Amendment Notice: Detectable Tile (Tactile Walking Surface Indicator, "TWSI") Installation Update.

- Architectural Standard Drawings and Specifications, Tactile Tile System Platform Plan, Sections and Details Type 2 (PC-002), Revision 2, dated May 9, 2023

Drawing Number
Dessin Numero
PC-002
REV2

Drawn: Dessin:	Checked: Verification:	NEW TACTILE TILE INSTALLATION ON EXISTING RAIL PLATFORM CURB PLAN, SECTIONS, DETAILS
Scale: Echelle: N.T.S.	Date: 2023/05/09

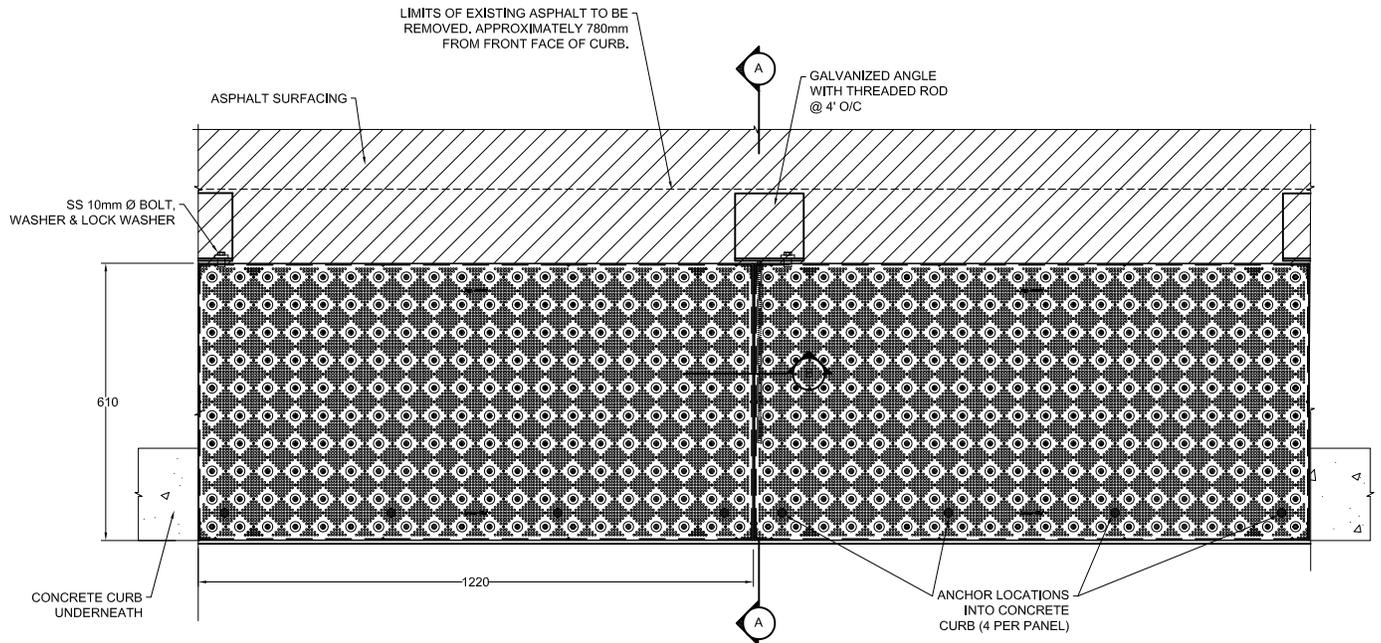
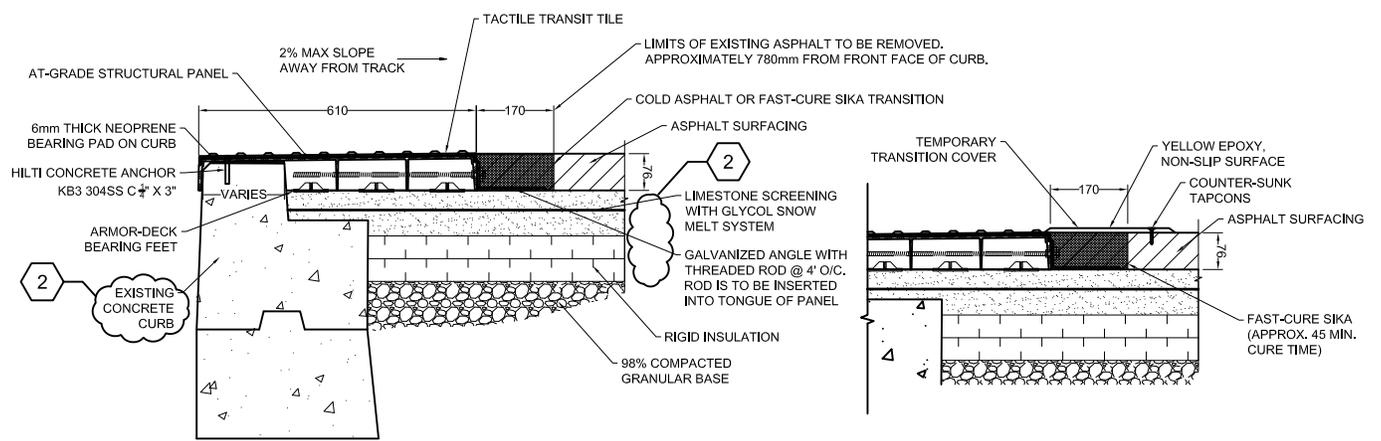
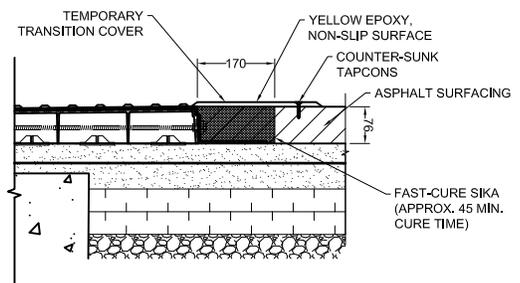
The purpose of this standard is to provide an Architectural Drawing Detail for which the installation method will reduce disruption to revenue service (without having to shut down the platform during TWSI tile installation). A new Detectable Tile Installation Drawing Detail has been added for use in addition to the existing Platform Curb Drawings.

The GO Standard Drawing, PC-002, applies in retrofit situations and in situations where a new installation causes disruption to GO Transit On Time Performance. It is applicable for platform curbs with and without glycol snow melt tubing. There is a resulting cost impact for Project Delivery Teams as the additional installation method is more expensive than current practice. Existing installation methodology remains acceptable provided that GO Transit On Time Performance is not compromised.

2. THE TRANSITION GAP BETWEEN REMOVED ASPHALT AND TACTILE TILE TO BE FILLED WITH COLD ASPHALT OR FAST CURE SIKA MORTAR.
 3. SCREENING TO BE ADDED OR REMOVED AS NECESSARY TO ENSURE THAT FINISHED INSTALLATION IS FLUSH WITH TOP OF PLATFORM.

4. PLATFORM SERVICE MUST REMAIN OPERATIONAL DURING ALL STAGES OF TACTILE TILE INSTALLATION.
 5. "AT-GRADE STRUCTURAL PANEL" REFERS TO STRUCTURAL REINFORCED POLYMER COMPOSITE DECK PANELS TO BE INSTALLED AND SUPPLIED BY CONTRACTOR. CONSULTANT/CONTRACTOR SHALL SUBMIT ALL APPLICABLE MANUFACTURER'S DATE, SHOP DRAWINGS AND GUARANTEE OF THE PRODUCT IN ACCORDANCE WITH SPECIFIED SUBMITTAL PROCEDURES.
